Plan Commission

Monday, March 25, 2019

SUBJECT: Recommendation regarding a Precise Implementation Plan (PIP) for 428 N. Superior Street (Parcel ED-477). Submitted by Joel Ehrfurth, Mach IV Engineering & Surveying, authorized representative for Irwin School Development LLC, property owner.*

REQUESTED ACTION:	Precise Implementation Plan (PIP) Required follow up to General Plan and Rezoning approvals granted in 2018.
COMMON DESCRIPTION:	428 N. Superior Street, also known as the Irwin School Property.
PARCEL NUMBER:	ED-477
EXISTING ZONING:	R-3 PDD (General Business District with a Planned Development District overlay)
SURROUNDING LAND USES:	R-2 Residential to the north, south, east, and west.
COMPREHENSIVE PLAN:	Commercial

DATE: 03.11.19
SHEET: C6.0

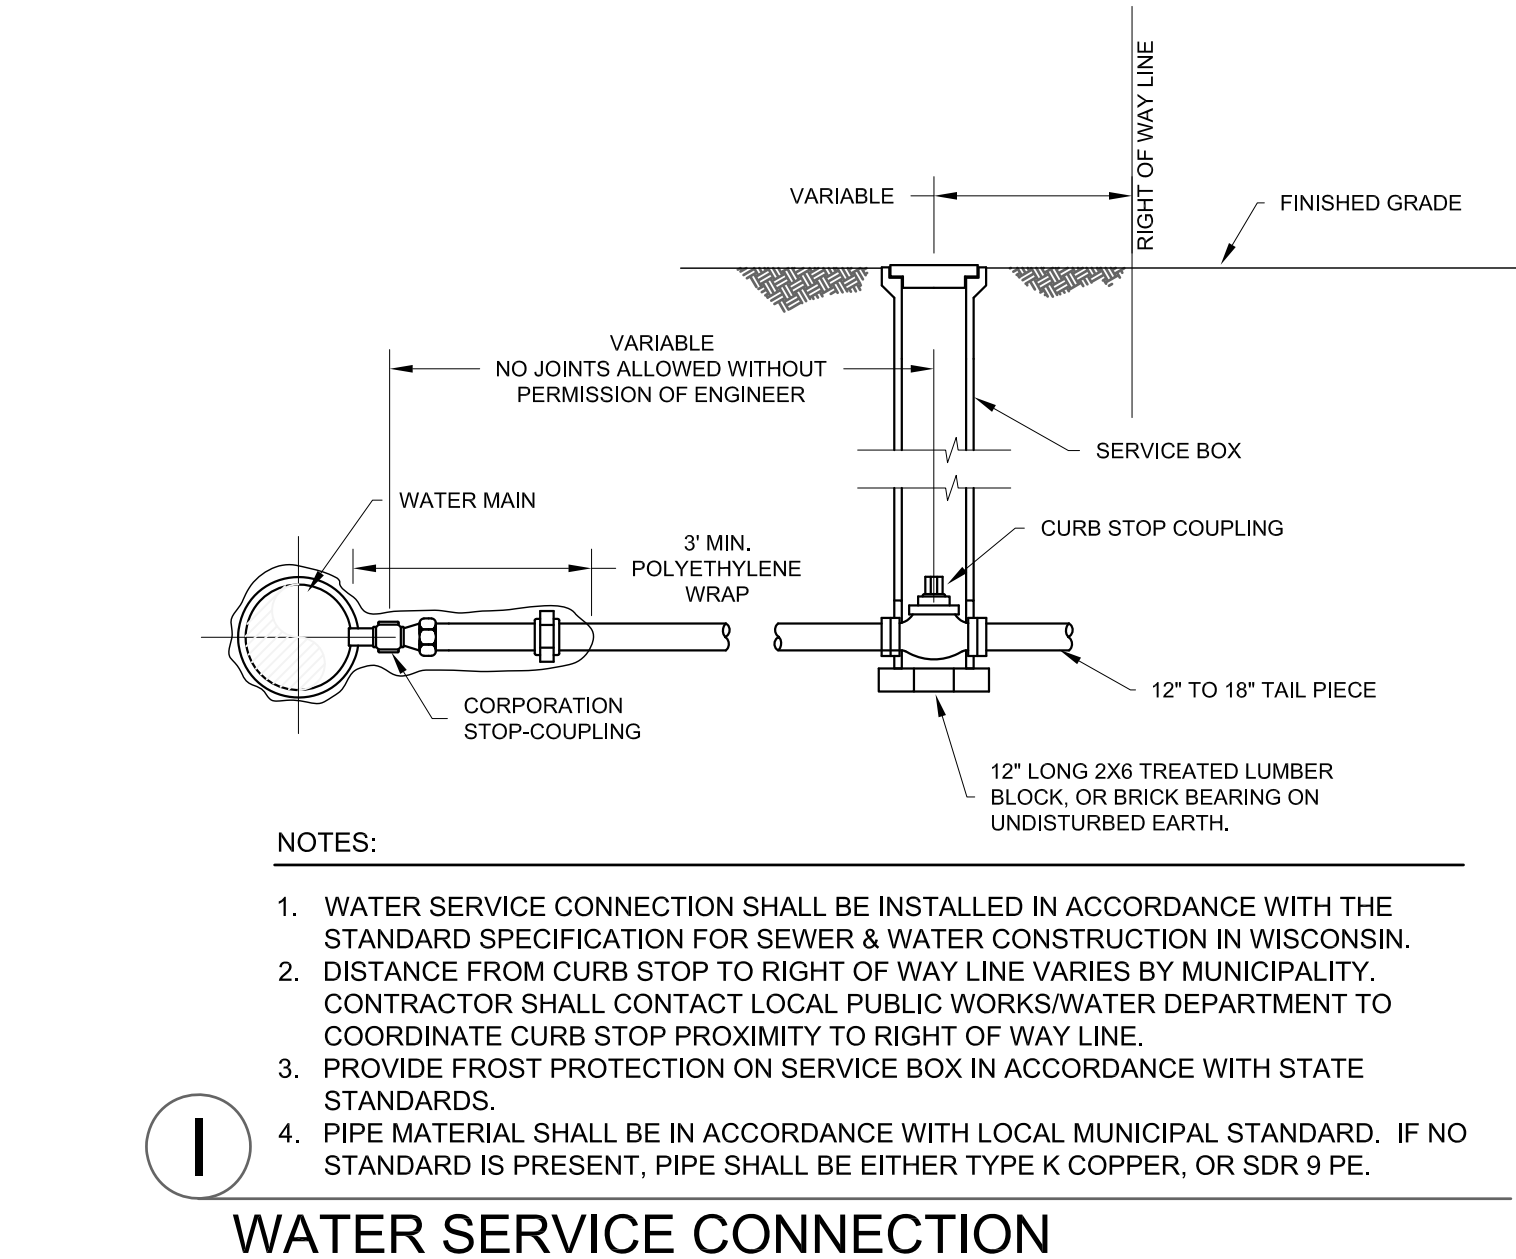
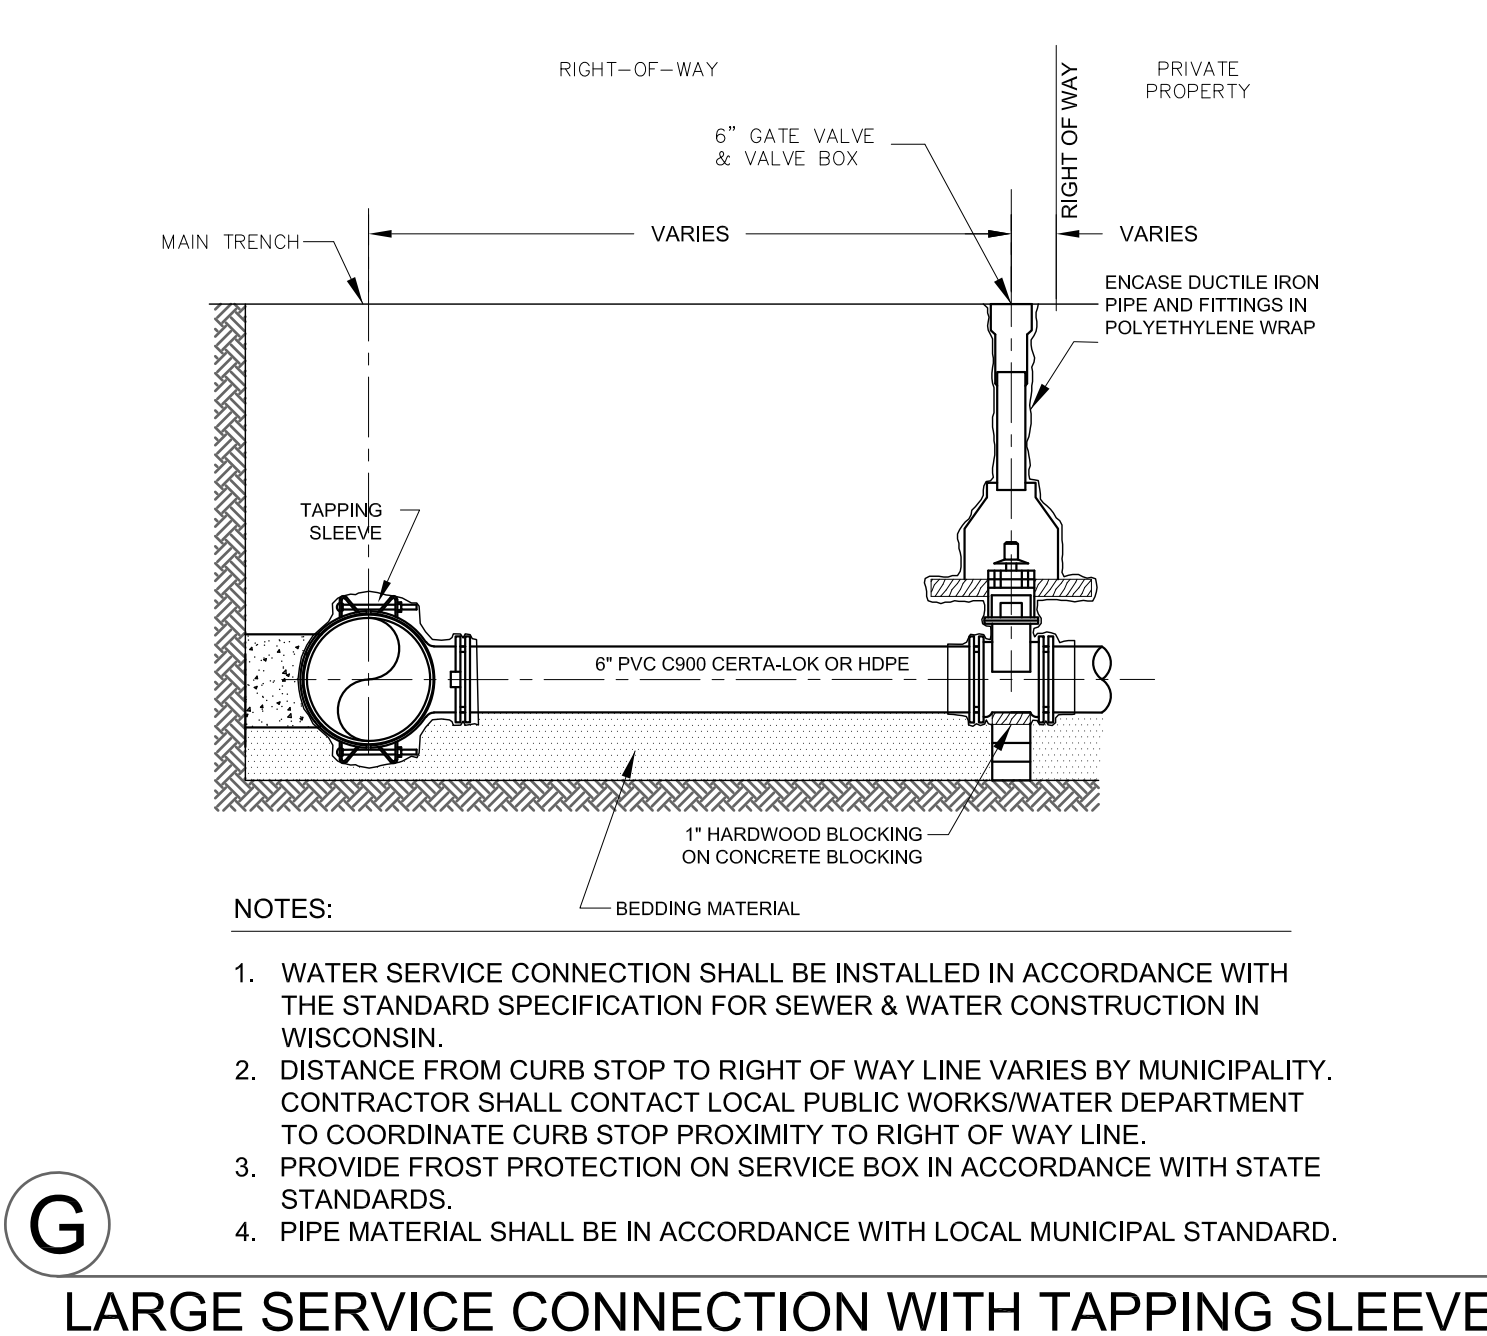
19. Sheet C5.0 - Need to see the WisDNR soil loss discharge calculations and corresponding map. This can be included in the SWMP.
20. Sheet C6.0 - Detail E needs to reflect 8-inch concrete for driveway aprons and sidewalks abutting driveways.
21. Add comment in the plan that all concrete work completed in the Public right-of-way must be completed by a licensed concrete contractor. Please contact De Pere Public Works at 920-339-4061 to obtain a list of licensed concrete workers or apply for a concrete worker's license.
22. Staff is still completing review of the SWMP. Additional comments may be provided pending its final review.
23. City will need to enter into a storm water maintenance agreement for the maintenance items listed in the SWMP. Agreement is to be provided by City staff.
24. Additional comments may be provided in response to changes made due to the items above.
